COMMONWEALTH OF MASSACHUSETTS DEPARTMENT OF PUBLIC UTILITIES

Investigation by the Department of Public Utilities on its own Motion into the Role of Gas Local Distribution Companies as the))) D.P.U. 20-80
Commonwealth Achieves its Target 2050 Climate Goals)
)

THE OFFICE OF THE ATTORNEY GENERAL'S INITIAL STAKEHOLDER COMMENTS ON CONSULTANTS' TECHNICAL ANALYSIS OF DECARBONIZATION PATHWAYS REPORT

Figure 9. Renewable gas supply curves in 2050 for optimistic and conservative Efficient Gas scenario.

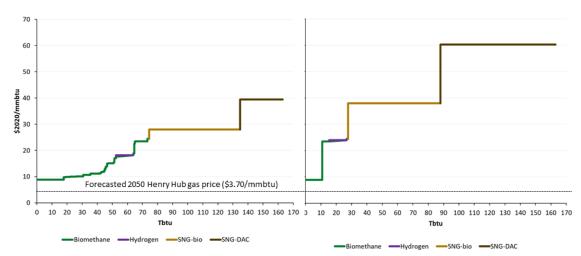
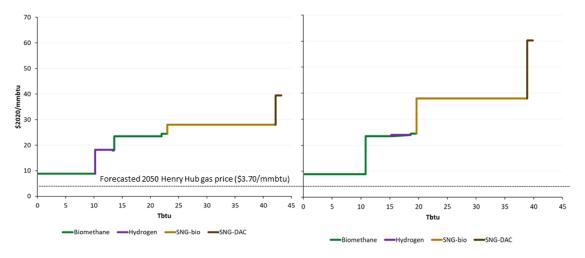
To estimate the cost of the future RNG supplies necessary for the climate success of hybrid electrification, E3 first constructs its own supply cost curves. *See, e.g.*, Appendix 1 to Technical Report, at 20, Figures 9 and 10. For convenience, these Figures are reproduced below.

To capture the future uncertainty in RNG pricing, E3 develops, to its credit, both "optimistic" and "pessimistic" views on renewable fuel supply curves. The x-axis (horizontal) on each graph

represents quantities of RNG available and the y-axis (vertical) corresponds to the unit price at each level of demand. The upward "steps" in prices as quantities increase along the x-axis reflects the much higher production cost for incremental quantities of biomethane, then hydrogen, and finally SNG as demand overall for RNG increases. (The AGO has not independently confirmed the reasonableness of the forecast quantities and prices of RNG in the foregoing cost curves, but for the sake of argument here assumes them to be reasonable.)

Inexplicably, and contrary to sound economic theory and its own pricing convention, the Technical Report disregards marginal (*i.e.*, market clearing) pricing when SNG is needed, in pathways with high gas demand. Whenever total RNG demand outstrips biomethane supplies in

E3's analysis, reaching into the SNG portion of the supply curve, the Technical Report abandons the concept of marginal pricing and a market clearing price. Instead, E3s pricing model is constructed to price the relatively small marginal quantities of SNG at the cost of SNG, but then proceeds to price the remaining RNG quantities at the lower cost of biomethane, below the margin of the supply curve.

What results from the Technical Report's special SNG pricing contrivance is a kluge of out-of-market RNG prices that imagines that most RNG is obtained at the (relatively low) cost of biomethane, and only the last, small incremental RNG requirement is priced at the much higher cost of SNG. In short, the Consultants' approach disregards competitive economics and the notion of a market clearing price. The resulting "weighted average" of lower contrived prices for biomethane but higher prices *only* for limited SNG quantities is counterfactual and economically unsupported, and significantly understates the cost of the gas-reliant pathways.

This pricing contrivance for SNG is no small error. As can be readily seen from Figures 9 and 10, above, the marginal, market-clearing prices of SNG (\$28-\$40/MMBtu for "optimistic" and \$40-\$60/MMBtu for "conservative" case) are multiples higher than the price for other RNG stocks. In the "optimistic" case, the Study assumes 63 TBtu (of the total 2050 requirement of 70 TBtu) can be attained from biomethane and hydrogen (Technical Report, at 52, Figure 16) leaving only 7 TBtu of higher cost SNG to be acquired at bilateral contract prices. But under the "conservative" case, only 16 TBtu of biomethane is available and the balance of 54 TBtu must be acquired from higher cost SNG stocks.

The resulting "Commodity Cost of Gas" shown in Figure 11 of Appendix 1 to the Technical Report could, if SNG were priced correctly, be roughly twice the cost E3 uses in its analysis. Market pricing of RNG would likely yield overall commodity gas costs far higher than the \$22-\$28 range shown for the Hybrid scenario in Figure 11. How much higher is not readily determined from the available information. The Department should insist that E3 correct its faulty SNG pricing contrivance and re-calculate the costs for all scenarios. The results would show that the overall savings the hybrid electrification scenario purportedly enjoys over high electrification scenarios would likely disappear (assuming, without conceding the point from Section III.A, that sufficient stocks of RNG could be found *at any price*).
